IREDELL COUNTY HEALTH DEPARTMENT

IMPROVEMENT PERMIT / AUTHORIZATION TO CONSTRUCT / OPERATION PERMIT / EXISTING SYSTEM INSPECTION

PERMIT# 38792 PIN# 4730031002 3002 DATE 2-22-07

Re: Cover material for line1 of lot 1, for Frank Lavery

AS BUILT SKETCH

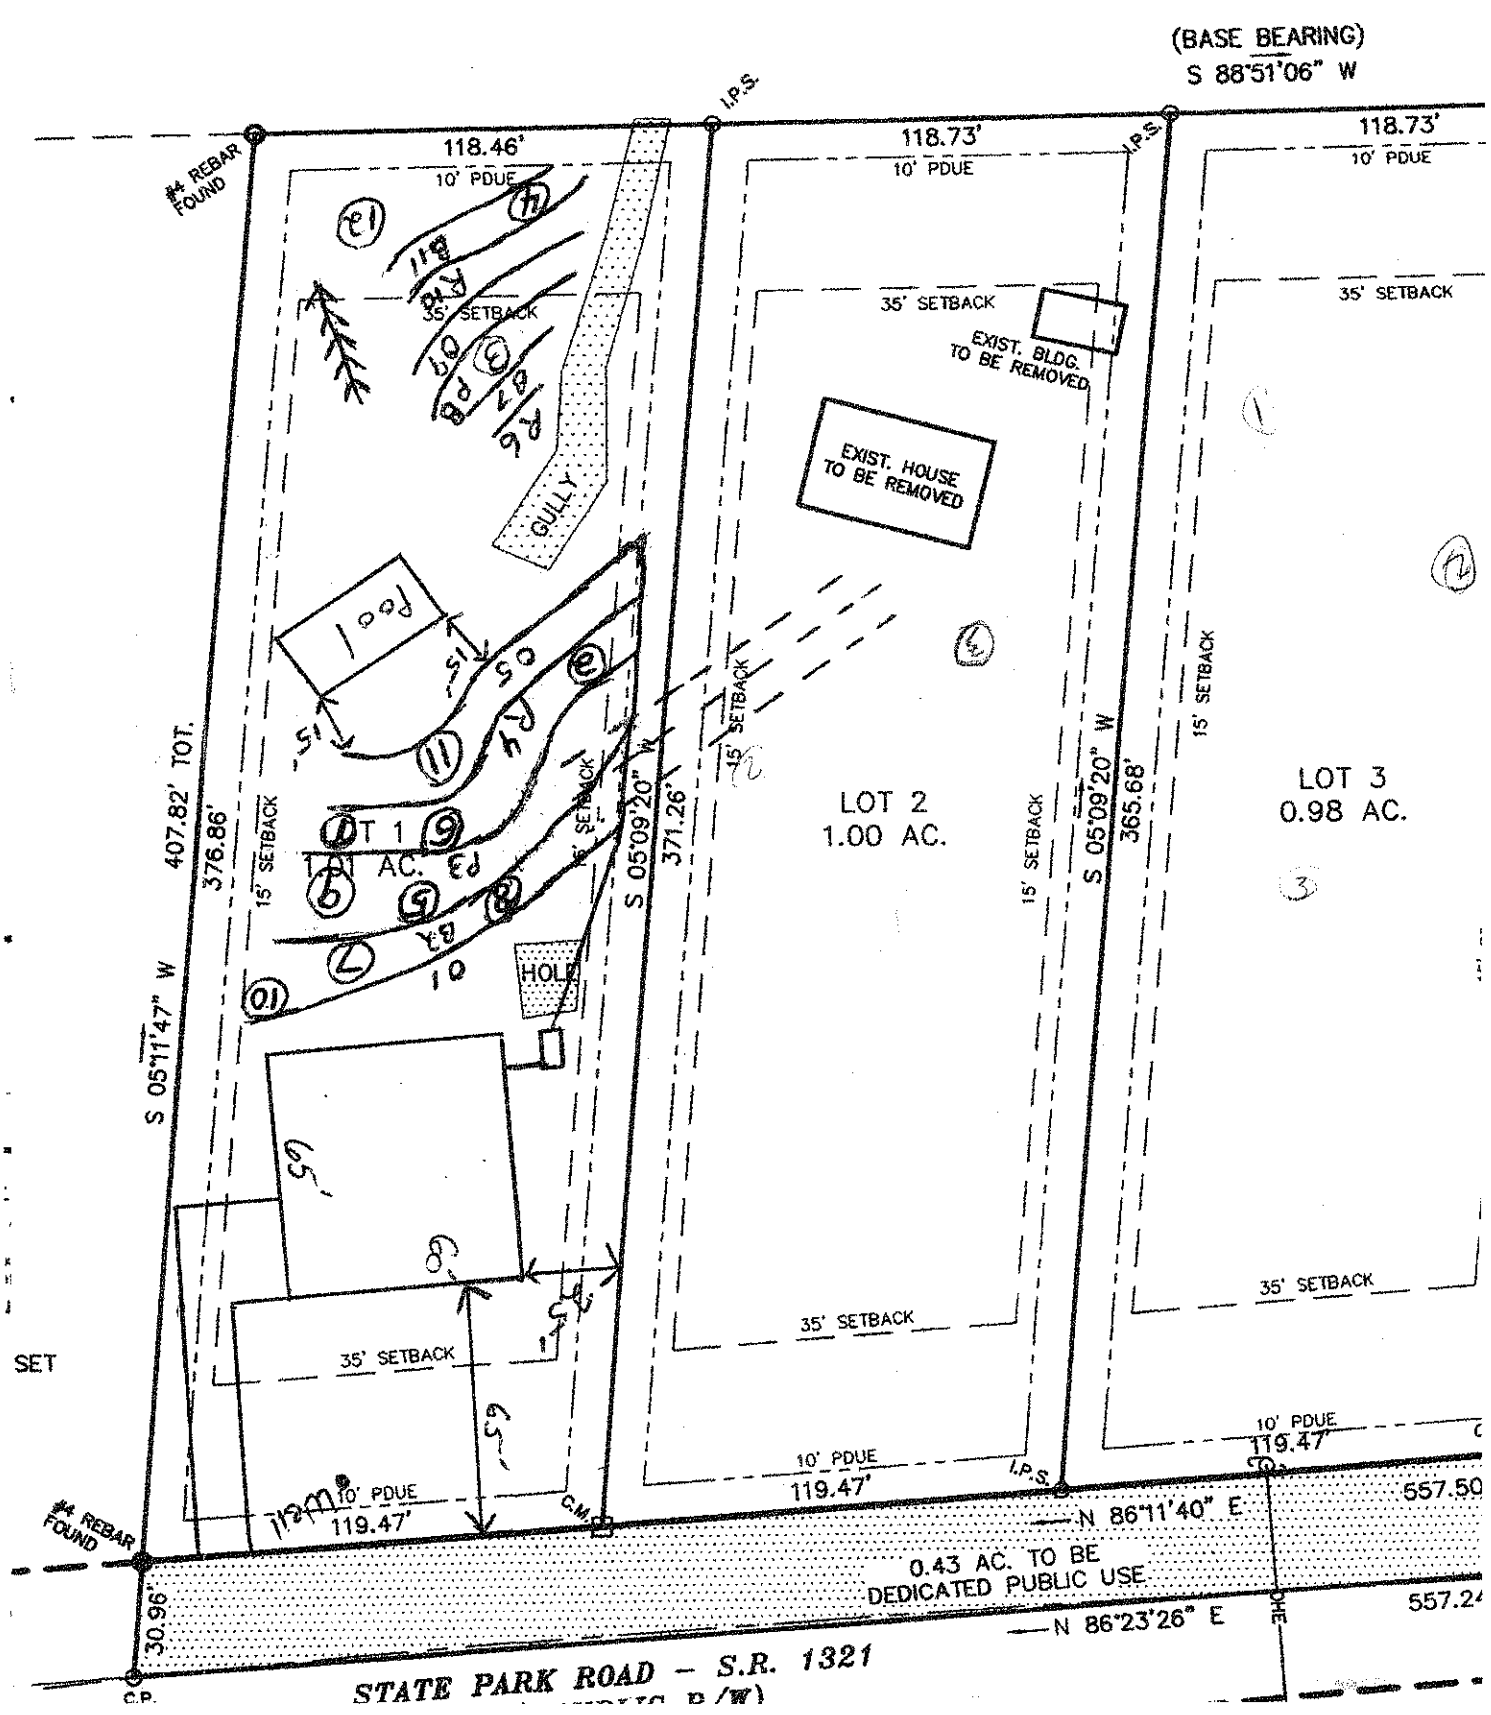
Comments:/Conditions: V'D Drainlines, TANK, & OLD SYSTEM Connection. NEEDS Cover Applied & Checked

* NOTE - Depths on Trenches Existing System

BUILDER ACKNOWLEDGED SYSTEM IS 10' ± OFF Property Line.

7/18/07 Probed V'D Cover. 1st Visit Turnaround

2nd Visit Probed HAS 6" of a SSL COVER. 7/19/07
